NORTHEAST NUCLEAR ENERGY COMPANY  
THE CONNECTICUT LIGHT AND POWER COMPANY  
THE WESTERN MASSACHUSETTS ELECTRIC COMPANY  
DOCKET NO. 50-336  
MILLSTONE NUCLEAR POWER STATION, UNIT NO. 2  
AMENDMENT TO FACILITY OPERATING LICENSE

Amendment No. 99  
License No. DPR-65

ATTACHMENT TO LICENSE AMENDMENT NO. 99

RELATED TO AMENDMENT NO. 99 TO DPR-65

**FIGURE 3.2-2a AXIAL SHAPE INDEX vs FRACTION OF ALLOWABLE POWER LEVEL per Specification 4.2.1.2c**

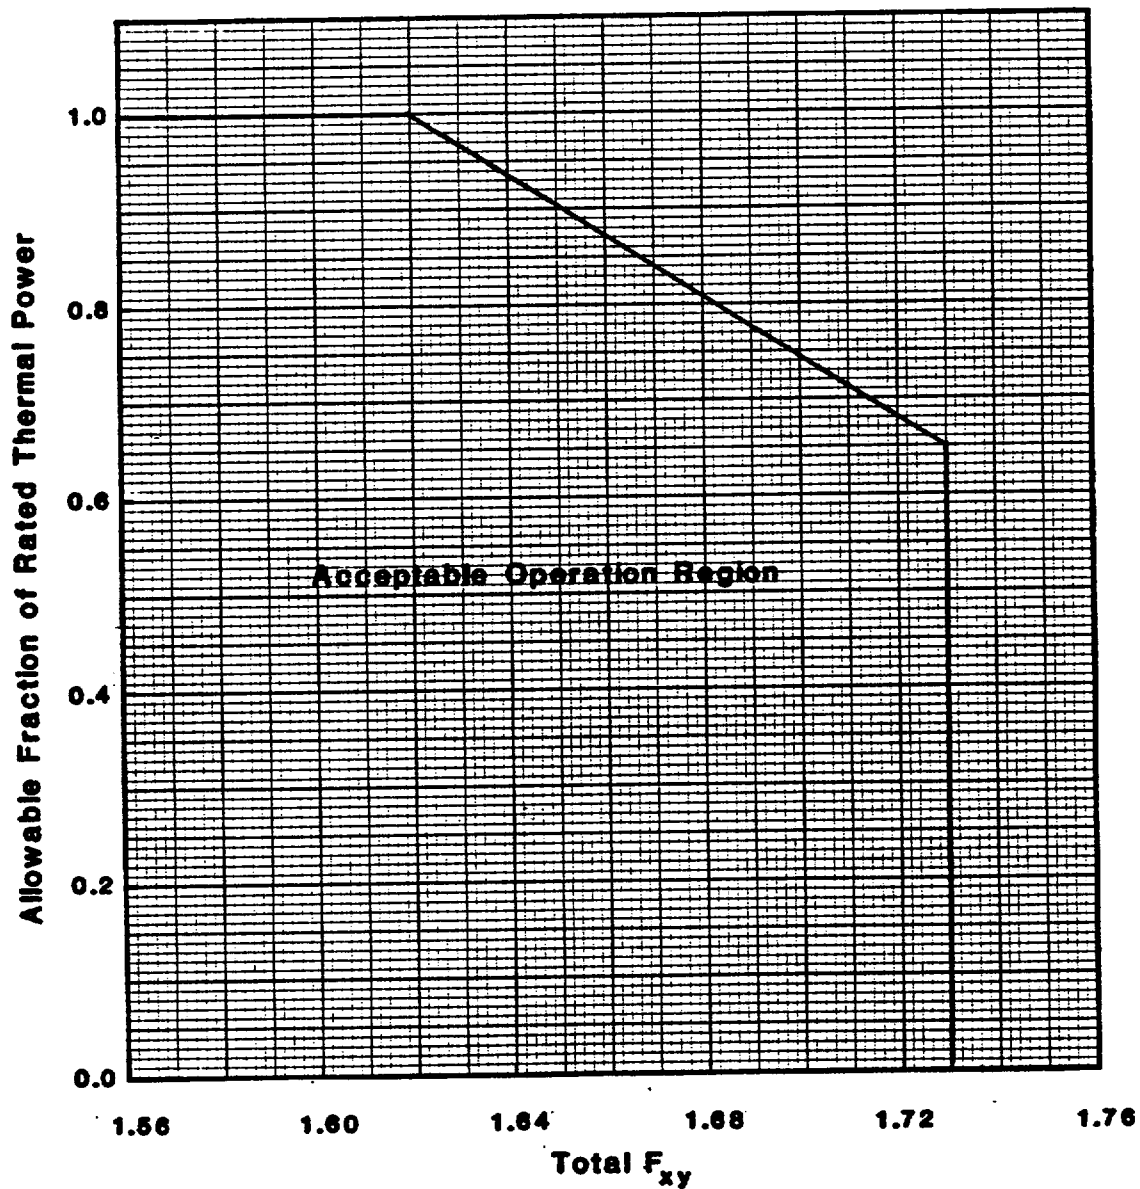
3.2.2.1 The calculated value of  $F_{xy}^T$ , defined as  $F_{xy}^T = F_{xy} (1+T_q)$ , shall be limited to  $\leq 1.62$  with the AXIAL SHAPE INDEX alarm setpoints adjusted consistent with the limits shown on Figure 3.2-2a, or

- a. With  $F_{xy}^T > 1.62$  and the AXIAL SHAPE INDEX alarm setpoints adjusted consistent with the limits shown on Figure 3.2-2a, within 6 hours either:

The main Technical Specification change proposed by the licensee trades range in radial peaking for more range in axial shape index (ASI). For monitoring of the power distribution with excore detectors, the maximum radial peak is specified in the Technical Specifications by a limit on the total planar radial peaking factor,  $F_{xy}$ . The maximum axial peak is specified by limits on the ASI. The product of the radial and axial peaks is the core peaking factor, which is proportional to the maximum peak linear heat rate. The maximum allowable peak linear heat rate in turn is limited as a result of the LOCA analysis to 15.6 kw/ft in normal operation of the powerplant. A decrease in the allowable value of  $F_{xy}$  can be offset with an increase in the allowable value of ASI without changing the limiting achievable linear heat rate.

The current Millstone Unit 2 Technical Specifications define an allowable ASI envelope for  $F_{xy} \leq 1.791$ . Also defined is a power derate curve if the  $F_{xy}$  limit cannot be met. The proposed Technical Specification change defines an expanded allowable ASI envelope and an appropriate power derate envelope if  $F_{xy} \leq 1.62$ . The licensee has indicated in Reference 1 that an analysis was performed to verify that the current envelope is unaffected by the hardware change in the

**FIGURE 3.2-2b AXIAL SHAPE INDEX vs FRACTION OF ALLOWABLE POWER LEVEL  
per Specification 4.2.1.2c**

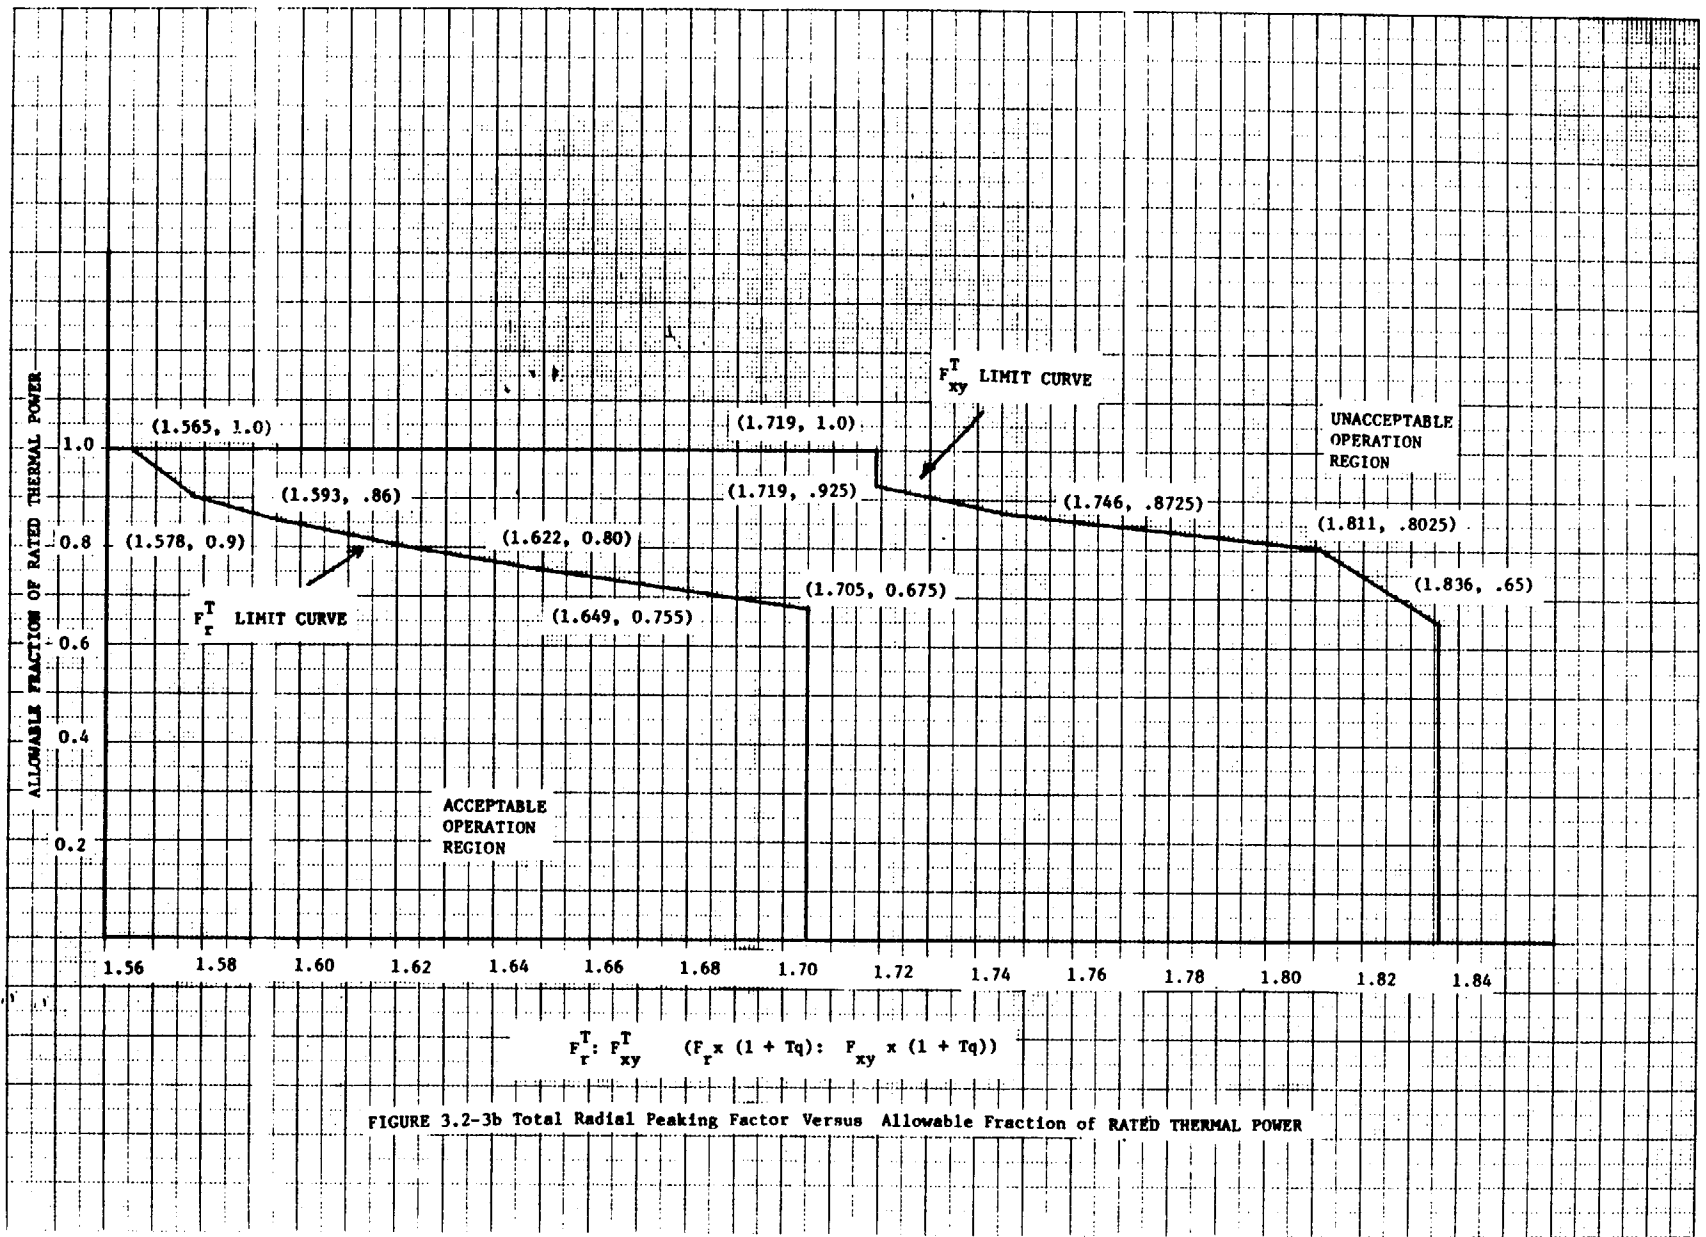
3.2.2.2 The calculated value of  $F_{xy}^T$ , defined as  $F_{xy}^T = F_{xy} (1+T_q)$ , shall be limited to  $\leq 1.719$  with the AXIAL SHAPE INDEX alarm setpoints adjusted consistent with the limits shown on Figure 3.2-2b.

- 2) Apply the limits of Specification 3.2.2.2 and Figure 3.2-3b and within 72 hours adjust the AXIAL SHAPE INDEX alarm setpoints consistent with the limits shown on Figure 3.2-2b, or
